Government of India-Ministry of Railways Research Design & Standards Organisation

MODIFICATION SHEET No. ELRS/MS/ 0304/2001, Rev. '0'

Replacement of existing 1/2" pipe line connected from MR3 reservoir through air flow measuring valve to port no. 1 of additional C2 relay valve and connected from port no. 3 of additional C2 relay valve to through and through brake pipe in Electric Locomotives with 1/4" pipe line.

SCHEMATIC SHOWING CHANGES REQUIRED IN BRAKE PIPE
CHARGING PIPE LINE

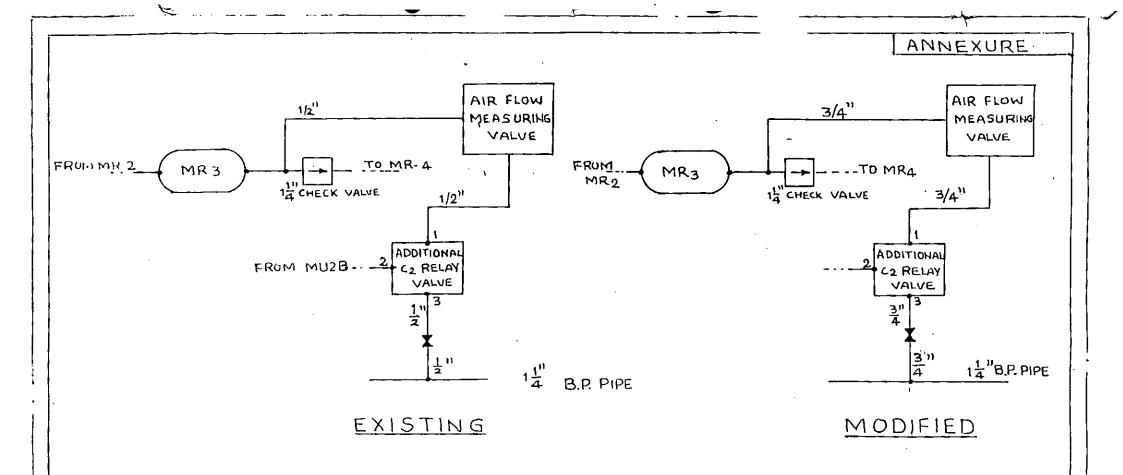
3.1 Existing pipe line connecting MR3 reservoir to air flow measuring valve and air flow measuring valve to port no.1 of additional C2 relay valve to be replaced with 34" pipe line

- 3.2 Existing ½" pipe line connecting port no. 3 of additional C2 relay valve to 1-1 4" through and through BP pipe in case of WAPI/WAP4 locomotives and 1" through and through BP pipe in case of WAPI/WAP4 locomotives to be replaced with 34" pipe line.
- 3.3 The pipe line size connected to port no. 1 and 3 of C2 relay valve for brake circuit of Electric Locomotive will remain as \(\frac{1}{2} \).

The schematic details are shown in the enclosed annexure.
